FINDINGS AND RECOMMENDATION OFFICE OF PLANNING AND ZONING ANNE ARUNDEL COUNTY, MARYLAND

CASE NUMBER: 2025-0084-V COUNCILMANIC DISTRICT: 4

REOUEST

The applicants are requesting a variance to perfect an accessory structure (shed) with less setbacks than required on property located at 339 Marganza South in Laurel.

VARIANCE SITE PLAN

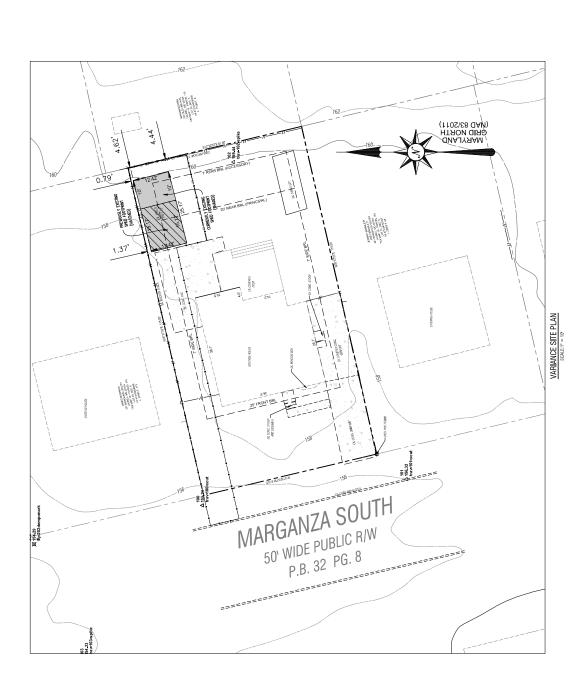
§18-4-701 of the Anne Arundel County Code requires that an accessory structure in an R5 District that exceeds 64 square feet in area and is eight feet or greater in height be set back a minimum of seven feet from the side lot line and seven feet from the rear lot line. The shed has been constructed as close as 0.79 feet from the northern side lot line and 4.44 feet from the rear lot line. As such, variances of 7 feet and 3 feet are required.

This Office notes that the property meets the area and width requirements for a lot in the R5 District.¹ The dwelling was built in 1963 according to State Tax Assessment Records. There is room on the lot to locate the shed without the need for a variance. Denial would not create a hardship in the use of the lot.

There are no physical conditions that are creating a hardship to locating the shed within the confines of the code. The lot is of adequate size and width for the district and there are no trees, wells, septic systems or other physical hardships creating the need for the shed to be in the current location. There is room on the property to locate the shed to meet setbacks without the need for a variance. Therefore, the variance request is unwarranted and cannot be considered to be the minimum necessary to afford relief.

With regard to the standards by which a variance may be granted as set forth under § 18-16-305 of the County Code, the Office of Planning and Zoning recommends *denial* of the variance request to § 18-4-701 of seven feet to the side lot line and three feet from the rear lot line to construct the shed as shown on the site plan.

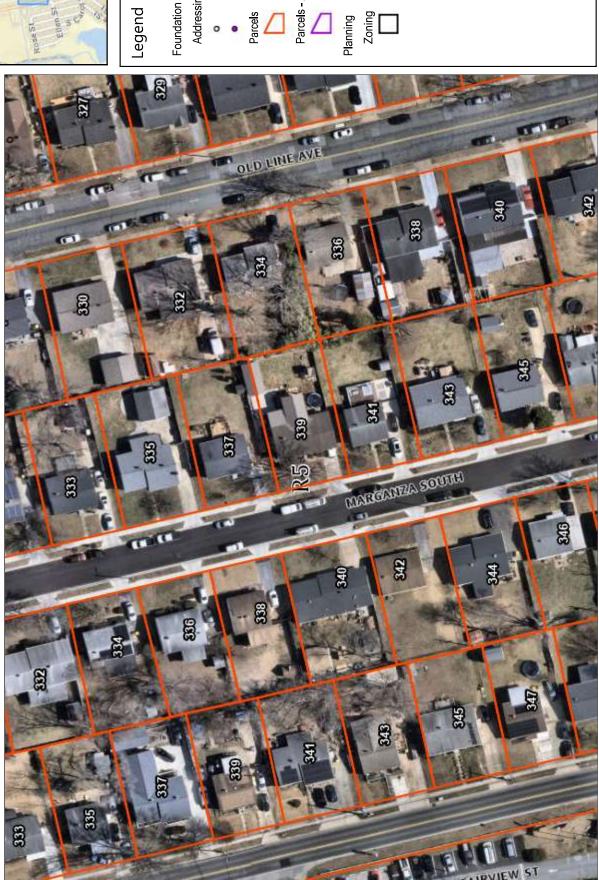
A review of the County aerial photograph from February 2025 shows primarily cookie-cutter rectangular lots and homes in this community. Accessory structures, particularly sheds, are common and have often been constructed close to property lines. Sheds less than 64 square feet are not required to meet setback requirements and can be placed next to lot lines. The subject shed can be seen in the photograph.
